Architectural Review Committee Staff Report Meeting Date: June 17, 2025

PETITION: Enclave at Deer Crossing Product Approval

REQUEST: Petitioner requests approval of the Winchester D – Modern Tudor for Lot 11 of the Enclave at Deer Crossing subdivision.

LEFT ELEVATION

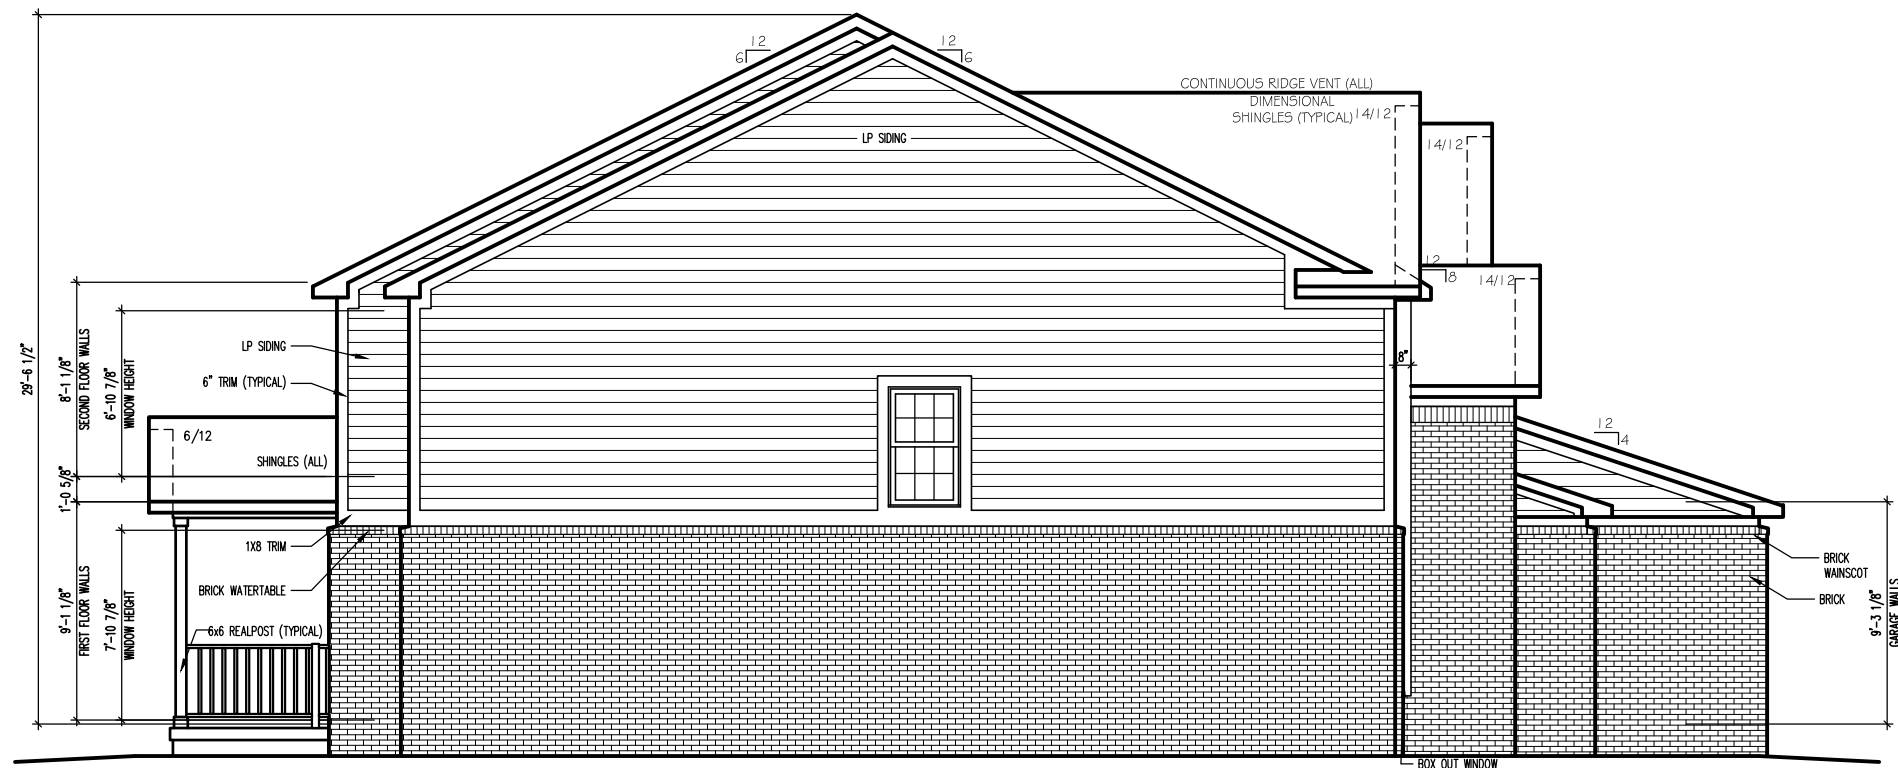
1. A minimum of three (3) windows are needed on the left elevation (facing a public street), and are required to feature shutters, mullions, or window grids.
